1968 Corvette: Service Bulletin: Choke and Hot Restart Problems

Model and Year: 1968 Corvette with 427 cu. in. Engine

Source: Chevrolet Dealer Service Technical Service Bulletin

Bulletin No: 68-T-23 Re-Issue

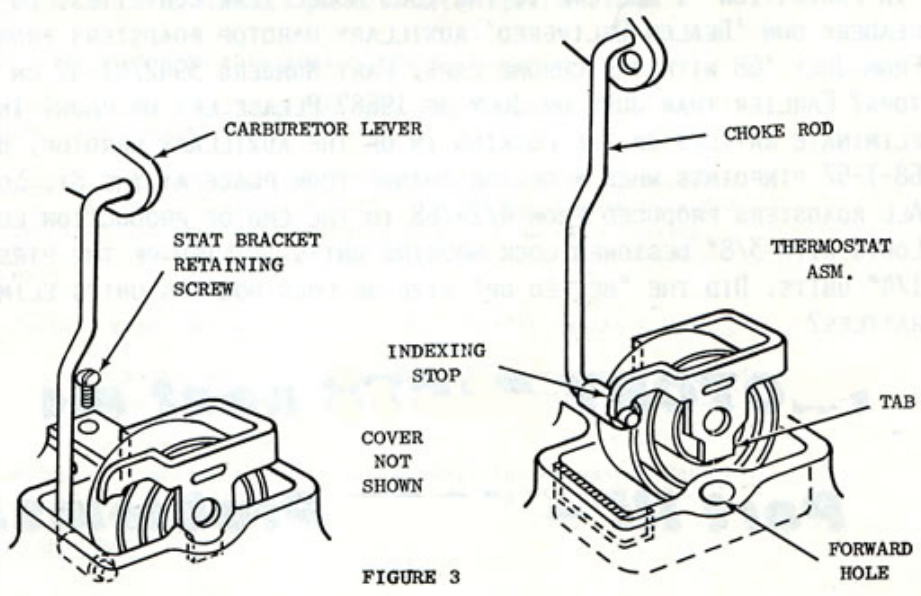
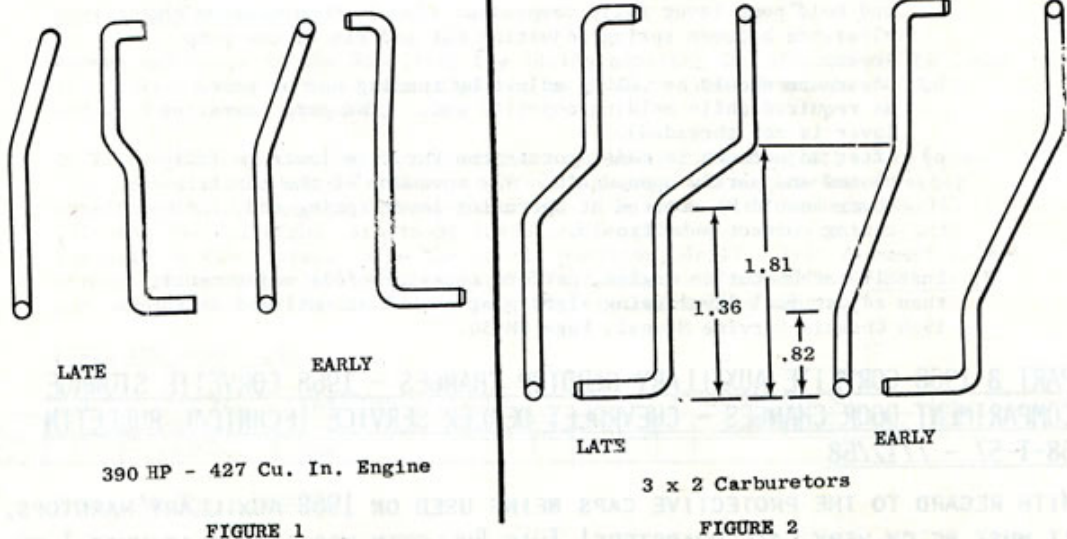
The hard cold starting problem may be due to interference or bind conditions of the choke rod, resulting in failure of the choke to move fully closed. Choke rod revisions corrected this possible condition with early October production vehicles. Field correction of this condition is outlined on Page2.

Install new choke rod (Part No. 3937738) which has a greater off-set and a reverse entry direction at the choke lever end. Adjust to one rod diameter interference by bending at the off-set as necessary.

Install new choke rod (Part No. 3919899) which has a greater off-set leg length and check for interference between choke thermostat coil and the manifold pocket as shown in Figure 3. If interference exists in this area, adjust the coil as much as possible on its mounting location, and if necessary, grind the pocket area or the choke rod end to gain clearance needed.
